State of Utah
DEPARTMENT OF NATURAL RESOURCES
DIVISION OF OIL, GAS AND MINING

RE: Deletion of Jensen Property Amendment Review, Mountain Coal Company, C.V. Spur, ACT/007/022, Folder #2, Carbon County, Utah

Re: Deletion of Jensen Property
Mountain Coal Company
C.V. Spur Processing/Loadout Facility
ACT/007/022-93A; Folder #2
Carbon County, Utah

JENSEN PROPERTY BERM (TYPICAL CROSS-SECTION)

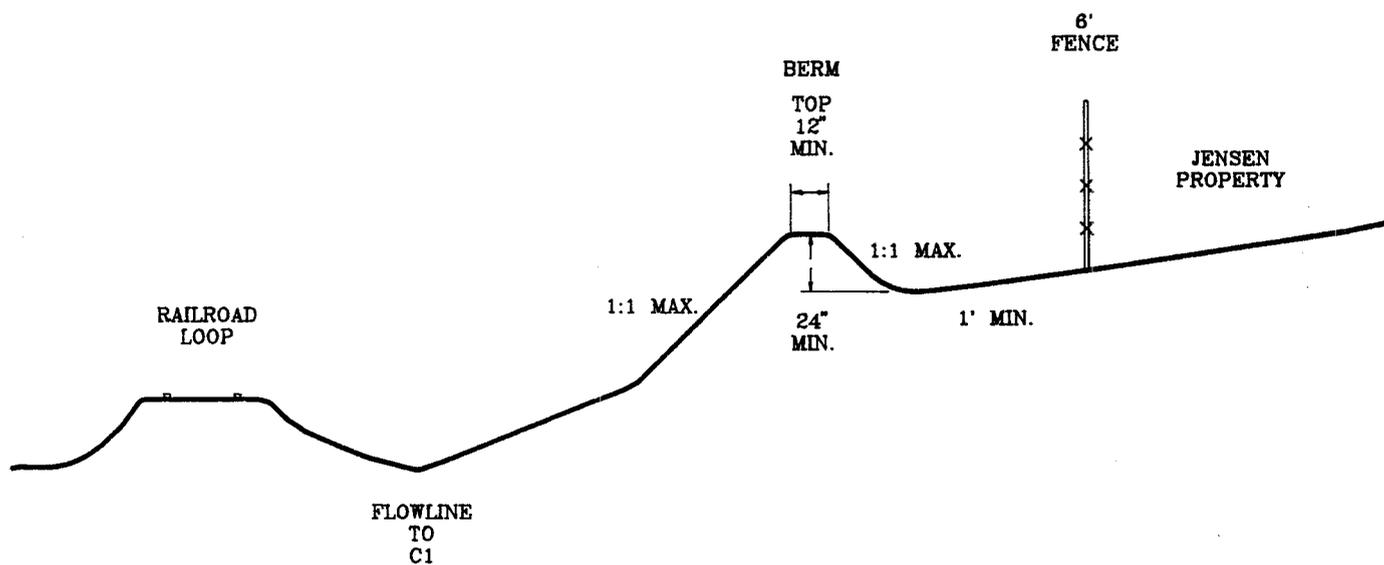
A berm is proposed along the southern border of the C.V. Spur property to divert runoff away from the C.V. Spur disturbed area. Design criteria for this berm were provided on page 7-87k. The berm is designed to be 24 inches high, 12 inches wide on top with 1:1 side slopes. It will divert runoff from the Jensen property east along the railroad track loop.

I recommend that this amendment be approved and incorporated into the MRP. The warranty deed, figure 4-2, from the original submittal, along with the revised plates and the text pages mentioned above will need to be incorporated. All plates with the exception of plate 4-1 show the revision 9/28/93 as the deletion of the Jensen property. Final copies of plate 4-1 will need to show this revision date also.

The proposed berm around the Jensen property will provide for diversion of drainage from this area eastward along the railroad loop to the 24" culvert beneath the main line of the railroad at the southeast corner of the property. Cross-Section of the proposed berm is shown on Figure 7-9, and location is shown on Plate 3-2.

The berm is more than adequate to divert the entire runoff from Area 5e shown on Figure 7-5 (p.7-65) and described on table 7-17 (p.7-69), which shows an expected runoff of only 0.318 acre feet with a design peak flow of 0.81 cfs (Culvert C-1, p. 7-88a),. Culvert C-1 will remain in place to divert drainage from the disturbed area remaining between the Jensen Property and the railroad loop.
